**PROJECT NO. ES 2024-11 COAL CREEK AND EAST BANK
AREAWIDE SEWER REHABILITATION**

**ADDENDUM NO. 1
TO
PROJECT NO. ES 2024-11 COAL CREEK AND EAST BANK AREAWIDE
SEWER REHABILITATION**

TMUA PROJECT NO. ES 2024-11 COAL CREEK AND EAST BANK AREAWIDE SEWER REHABILITATION

RIVERSIDE DRIVE TRAFFIC DETOUR PLAN
 TMUA PROJECT NO. ES 2024-11
 COAL CREEK AND EAST BANK
 AREA WIDE SEWER REHABILITATION, FY24
 CITY OF TULSA, OKLAHOMA
 WATER AND SEWER DEPARTMENT

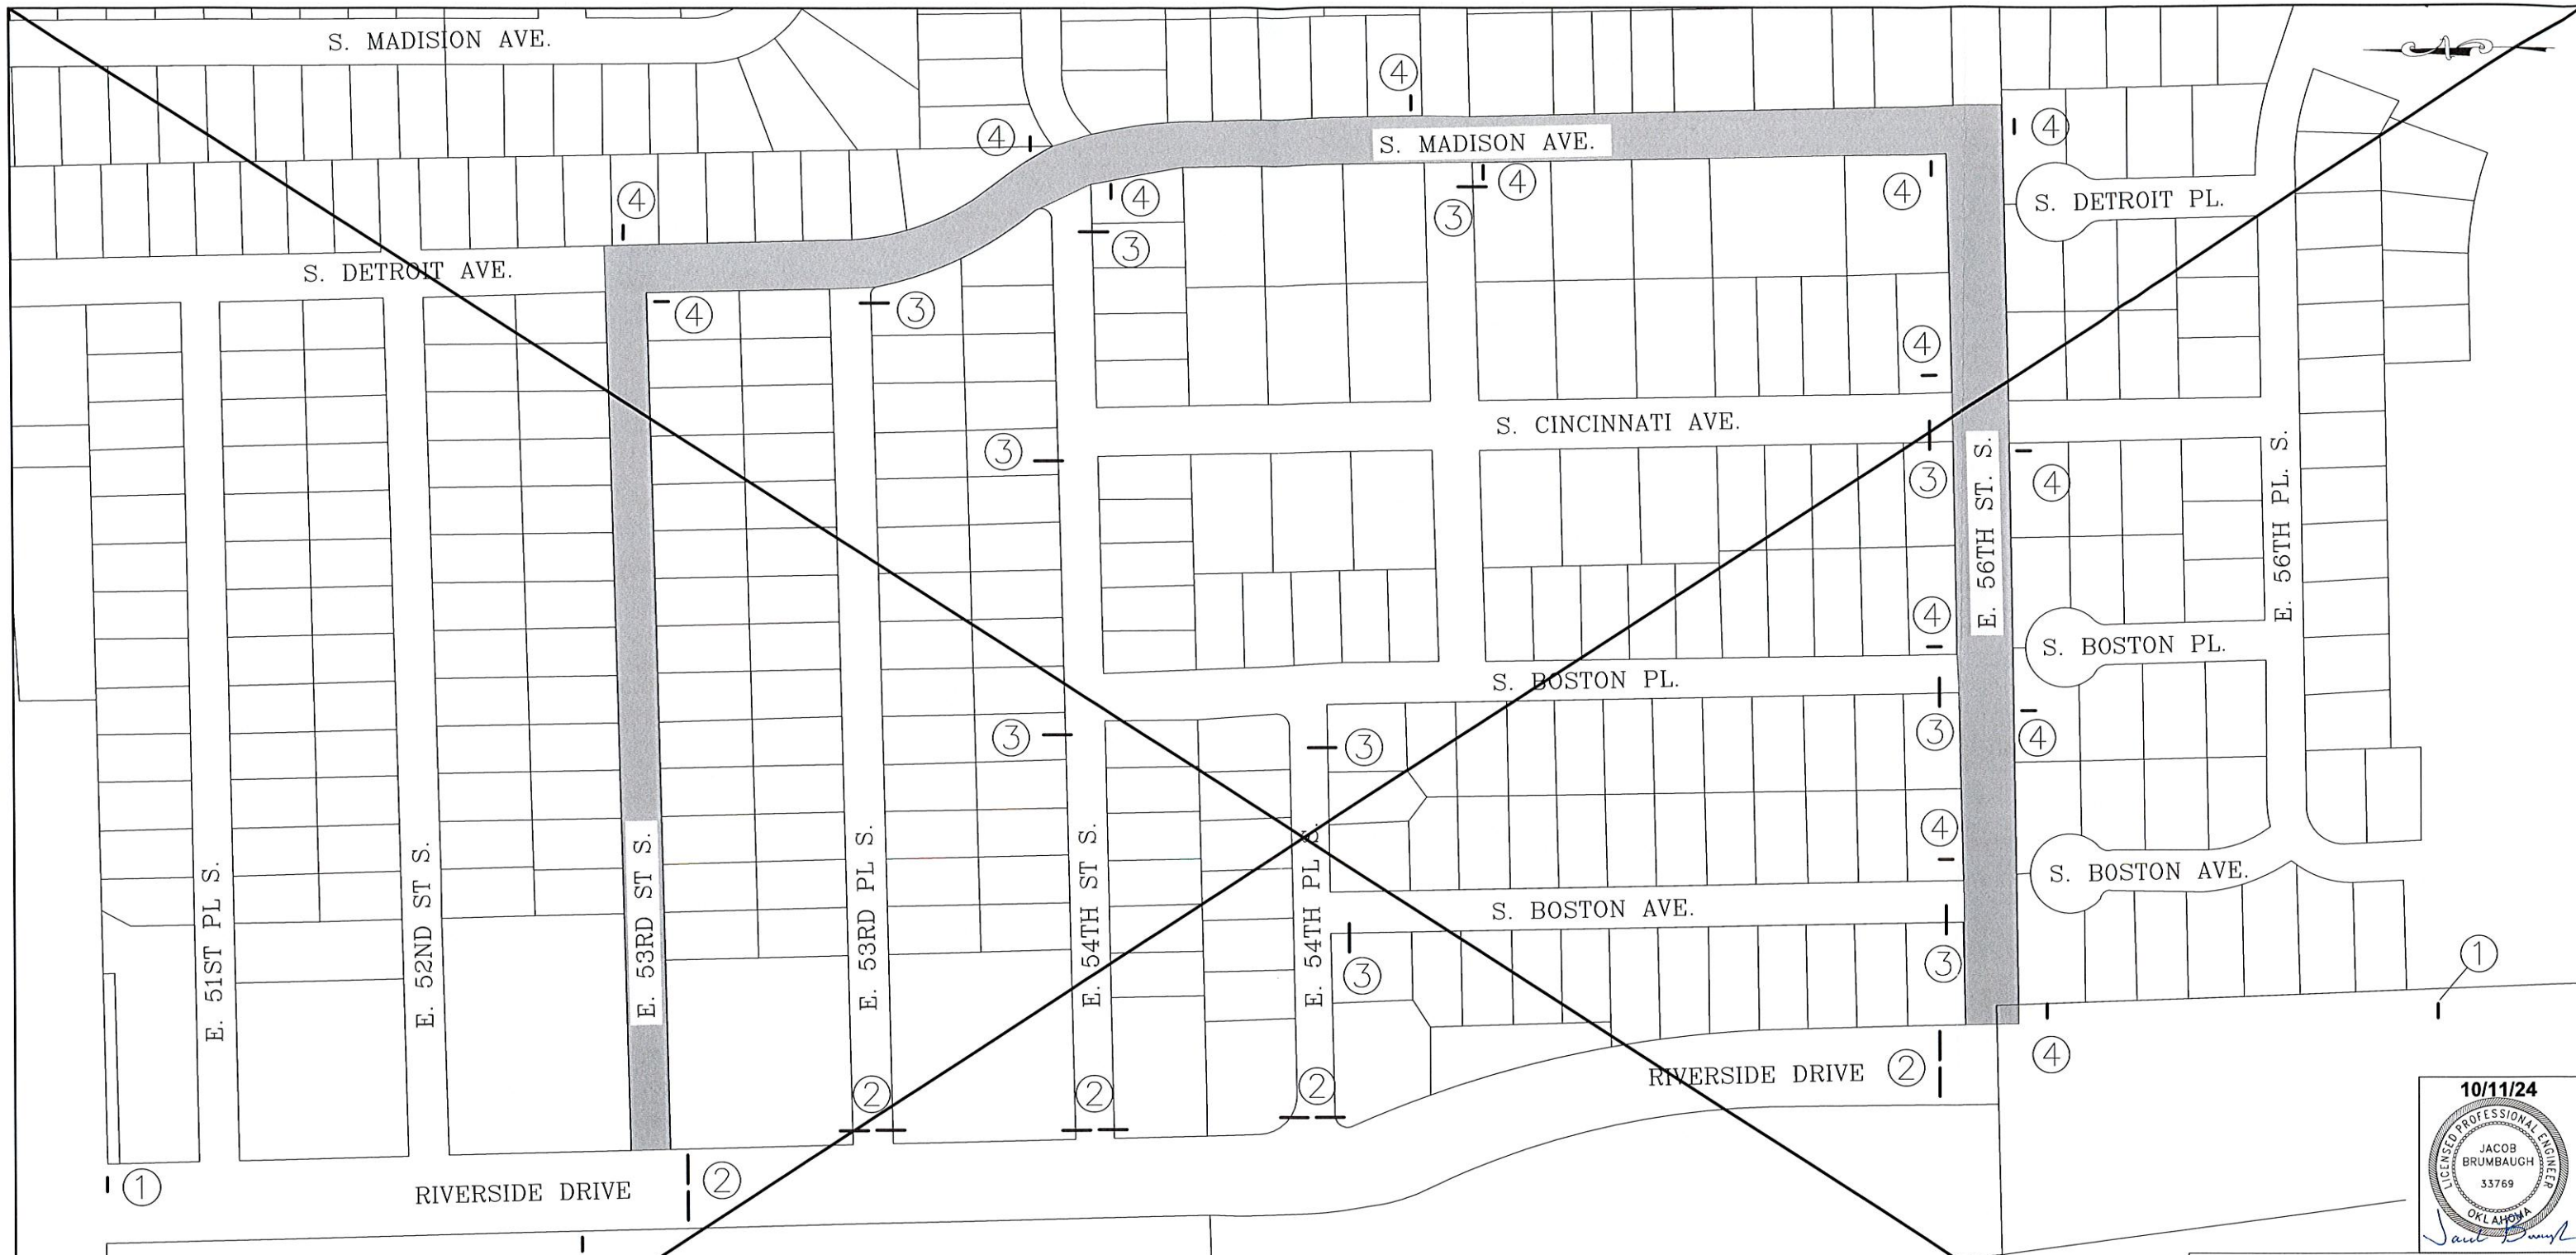
6. Sheet 33: Removed bypass pumping (2) from the plan sheet.
7. Sheet 35: Deleted the sheet from the plan set. The detour plan is not required since bypass pumping for rehabilitation of existing manhole 047-0783 is no longer required.

REMOVED FROM CONTRACT
